**LEVY NUCLEAR PLANT, UNITS 1 AND 2
DOCKET NOS. 52-029 AND 52-030
SUPPLEMENTAL RESPONSE TO NRC RAI LETTER 124 – SRP SECTION 6.3 AND NRC
RAI LETTER 116 – SRP SECTIONS 6.3 AND 15.2.6 TO ADDRESS CONTAINMENT
CONDENSATE RETURN COOLING DESIGN**

**Levy Nuclear Power Plant Units 1 and 2
Revised Response to Selected Questions from NRC Request for Additional
Information Letter No. 116 Related to SRP Sections 6.3 and 15.2.6 for the
Combined License Application, dated March 6, 2014**

NRC RAI #: 06.03-9

Figure 1: Original Analysis Approach

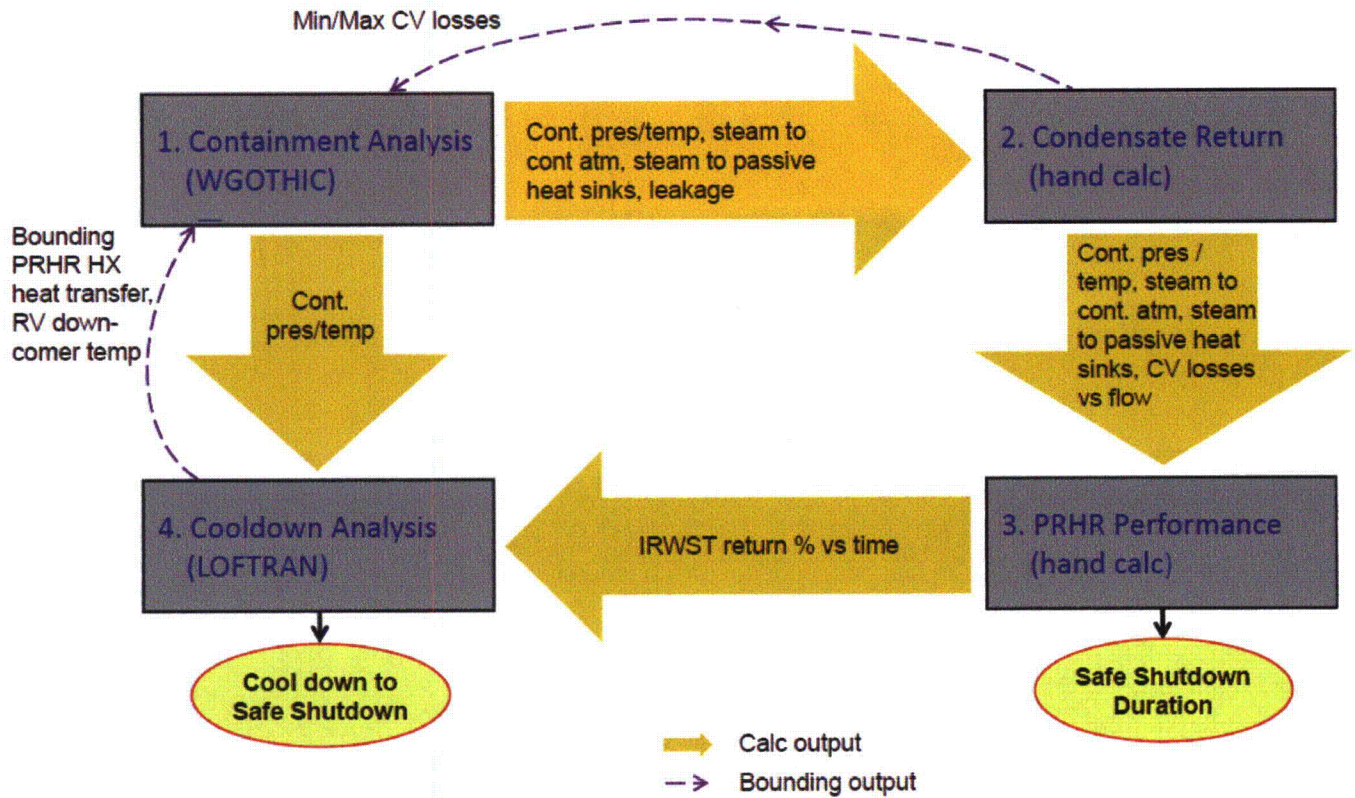
Figure 9 of the Levy submittal dated February 7, 2014, provides an illustration of inter-relationships of four calculations.

- a. Explain this figure describing how information flows from one calculation to the other for design basis and best estimate calculations.
- b. Explain how information flow loops are addressed. For example, APP-PXS-M3C-071 feeds containment pressure and temperature to SSAR-GSC-536, which feeds back bounding PRHR HX heat transfer and reactor vessel downcomer temperature to APP-PXS-M3C-071, creating a loop.

Figure 1 below shows the original interrelationship between the four calculations for the design basis and conservative, non-bounding analysis cases.

“1. Containment Analysis” provides inputs into “2. Condensate Return”. The main inputs include the containment pressure and temperature, mass of steam that condenses on heat sinks, mass of the steam that is in the containment atmosphere, and steam lost due to containment leakage. These values were solved by starting with WGOTHIC containment peak pressure model from revision 19 of the DCD and making changes to develop a conservative containment response to model condensation losses during Passive Residual Heat Removal (PRHR) Heat Exchanger (HX) operation.

“1. Containment Analysis” uses a bounding PRHR HX heat transfer rate and Reactor Vessel (RV) downcomer temperature input from the “4. Cooldown Analysis”. The input from “4. Cooldown Analysis” provides a PRHR HX performance that is bounded on the high end to maximize the steam generated from the IRWST. The RV downcomer temperature is used to generate steam from the RV, which heats the lower portions of containment. The use of a bounding input avoids the need to iterate the calculations.

"4. Cooldown Analysis" also provides a bounding input to "1. Containment Analysis" for the PRHR HX heat transfer rate and RV downcomer temperature as discussed above. By using this bounding input the need to iterate the calculations is eliminated.
